## PLANNING RATIONALE ADDENDUM #1

Fotenn Consultants Inc. (Fotenn) has been retained by Minto Communities (Minto) to submit and monitor a Zoning By-law Amendment and Draft Plan of Subdivision applications for the lands municipally known as 936 March Road in the Kanata North community of the City of Ottawa (subject lands).

Figure 2: Typical Lotting Standard and Measurements: (Left) 30' Single Detached Homes (Right) 36' Single Detached Homes

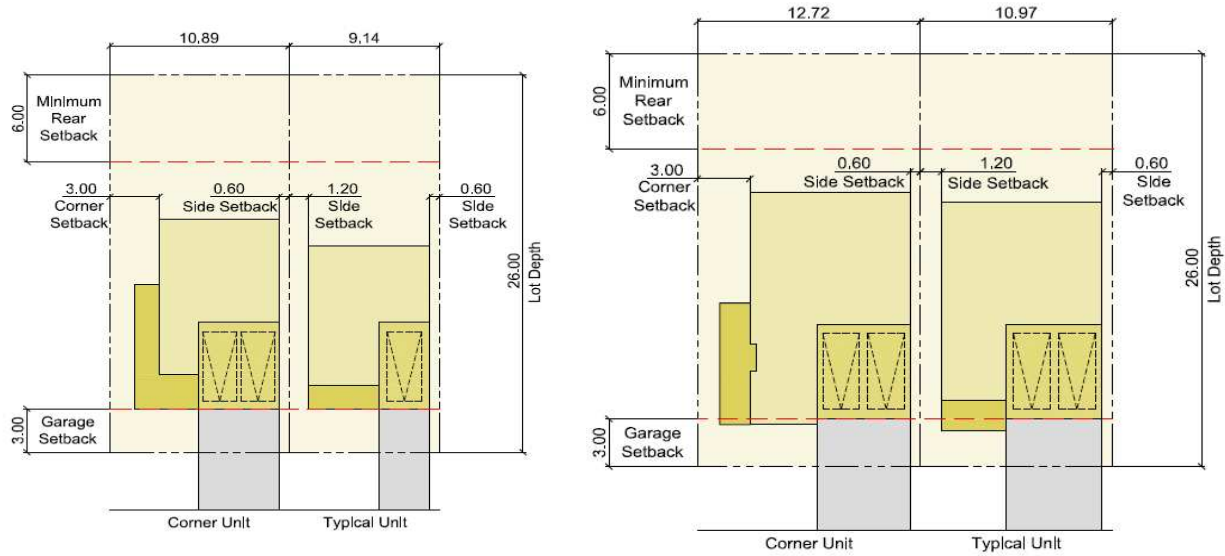
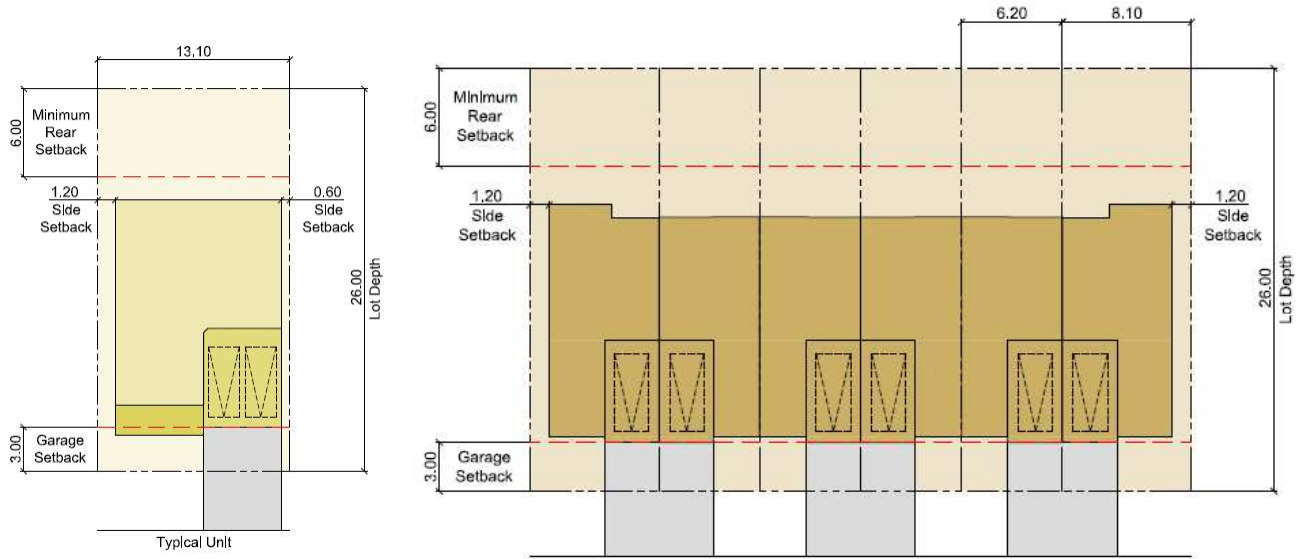
**Please confirm what exceptions are required from the R3Z zoning. If required, please include any required driveway width exception for corner units with double car driveway.**

As a result of the current lot configuration, Minto is proposing the R3ZZ zoning with an exception similar to what was implemented in the Mattamy Lands in Kanata, South of Palladium Drive. The exception would include the following performance standards:

- / **Zone requirements for detached dwellings:**
    - minimum lot area is 220 m<sup>2</sup>
    - minimum lot width is 8.8 m
    - minimum front yard setback is 3 m for the principle building and for an attached garage
    - minimum combined interior side yard setback is 1.8 m with a minimum of 0.6 m on one side
    - minimum corner side yard is 2.5 m
    - maximum lot coverage is 55%

- / **Zone requirements for semi-detached and townhouse dwellings:**
    - minimum lot area is 137 m<sup>2</sup>
    - minimum lot width is 5.5 m
    - minimum front yard setback is 3 m for the principle building and attached garage
    - minimum side yard is 2.5 m
    - minimum rear yard setback is 6 m,
    - maximum lot coverage is 65%
    - maximum building height is 12 m
